**Fixing EPD and LPD in IEEE Std 802-2014**

**Venue: 802.1 Maintenance TG, related to IEEE Std 802-2014**

This document proposes maintenance corrections in the description of EtherType Protocol Discrimination (EPD) and LLC Protocol Discrimination (LPD) in IEEE Std 802-2014.

Summary understanding of the EPD, LPD, LLC Encoding, and L/T Encoding

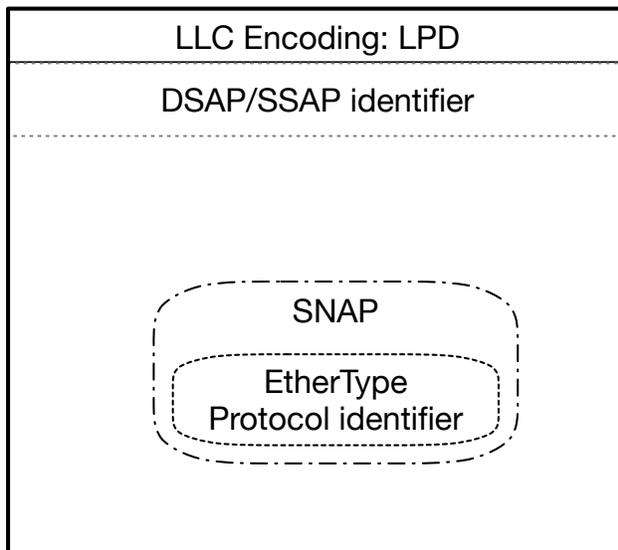
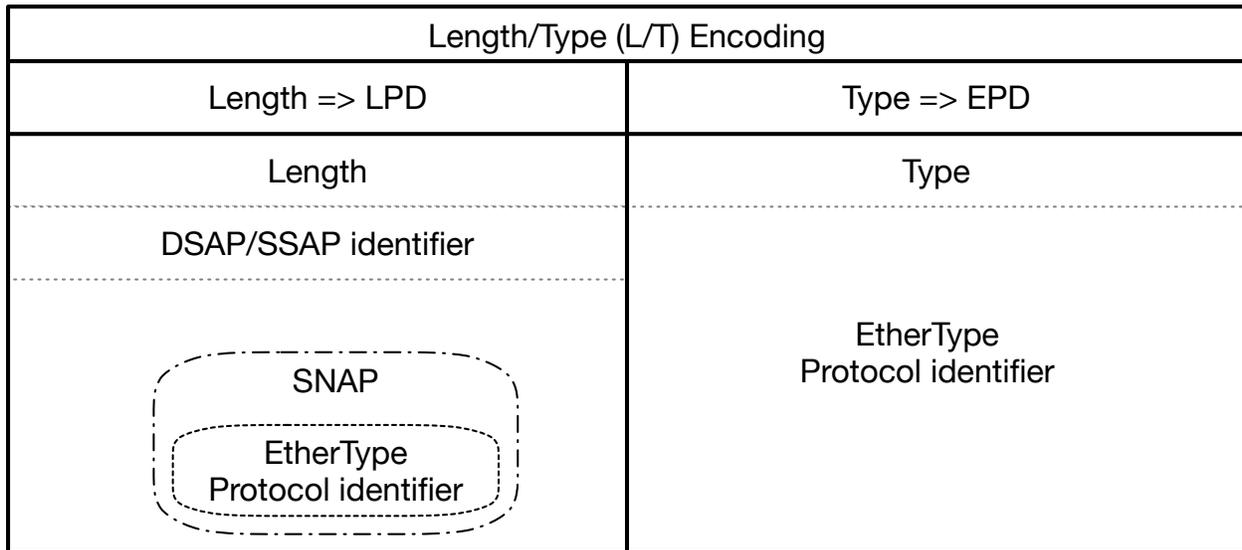
- EtherType protocol discrimination (EPD) and LLC protocol discrimination (LPD) are discussed in IEEE Std 802, IEEE Std 802.1AC, and IEEE Std 802.1Q; IEEE Std 802.11 too.
- Overall, the descriptions are imprecise, inconsistent, and confusing.
- This contribution proposes, as a first step, making some changes to IEEE Std 802-2014 within an amendment (such as IEEE P802f). Efforts are being made to align IEEE 802.11.
- Larger updates to IEEE Std 802 could be addressed in a follow-up revision.
- IEEE Std 802.1Q and 802.1AC will be addressed next.
